DWG NO. 564420 SH 1 RE

APPLICATION			REVISIONS			
PART NO.	NEXT ASSY	USED ON	REV	DESCRIPTION	DATE	APPROVED
		IN0112A	-	INITIAL RELEASE		W. ANDERSON
				AS RUN Red line

Note: All steps calling for UDT photometer are N/A because the photometer was out of the facility during these tests. These photos were calibrated using an ASD spectrophotometer on Mar 20, 2003 DLH 4/23/03

**Medium Resolution Instrument (MRI)  
Performance Test Procedure**

**Figure 8-2 Integrating Sphere Mechanical Setup**

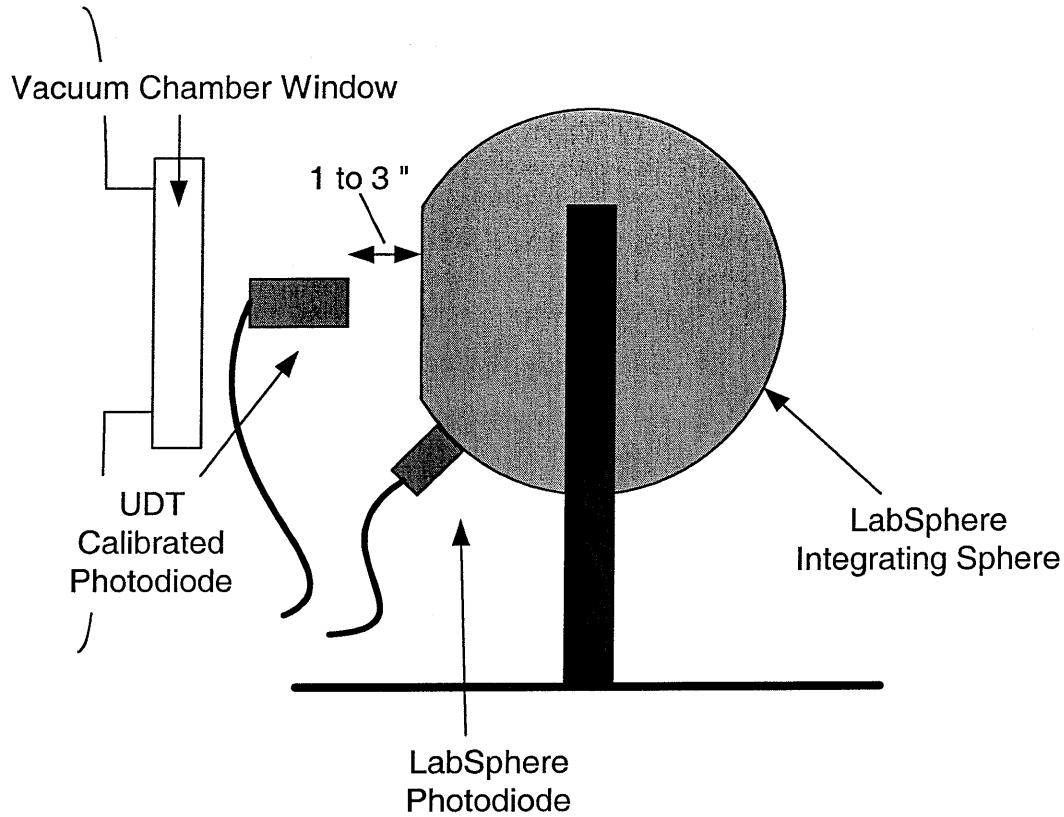
*Handwritten note:* Note used 20" fold flat on optical test station 2 over for diagram →
